**FEDERAL COMMUNICATIONS COMMISSION**  
**445 12th Street, S.W.**  
**WASHINGTON DC 20554**

In re: W270BI, Lantana, TN  
BPFT-20110830AEJ  
Facility ID # 142683

Petition for Reconsideration

THE FOLLOWING IS A LIST OF THE DATA WHICH APPEARS ON THE ABOVE MAP

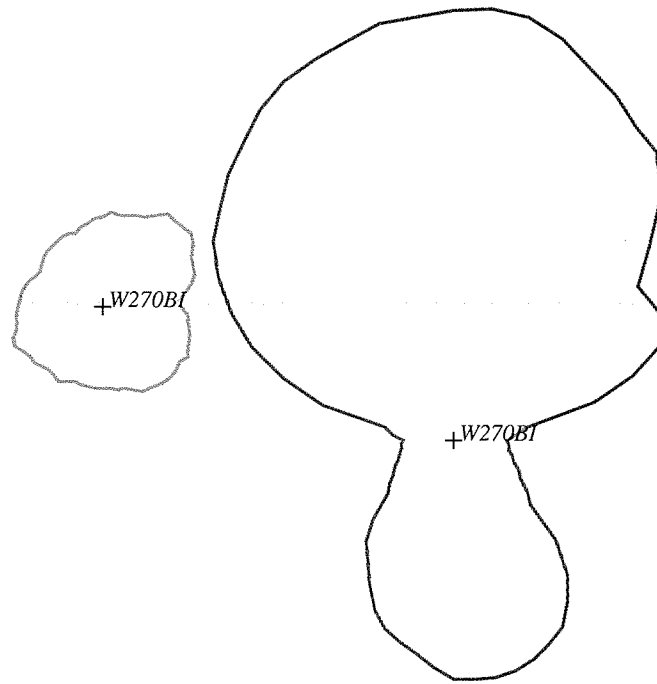
The applicant indicated that the amended directional antenna pattern will eliminate the overlap between the proposed translator, WJSQ(FM) and WWST(FM). Our further review of the amendment has created a different violation. The application is a violation of 47 C.F.R. § 74.1233(a)(1). Specifically, the Section states that "a major change is... any change in antenna location where the station would not continue to provide 1 mV/m service to some portion of its previously authorized 1 mV/m service area." The proposed service area would not continue to provide service to some portion BLFT-20070917ADK service area. Because major change applications are not being accepted for filing, the amendment is unacceptable for filing and we will dismiss the petition for reconsideration.

Accordingly, the amendment is unacceptable and IS HEREBY DISMISSED and the petition for reconsideration filed on October 20, 2011 by Tennessee Valley Translator Association IS HEREBY DENIED.<sup>1</sup> Please note that if the applicant desires to pursue this proposal, it may submit a new application.
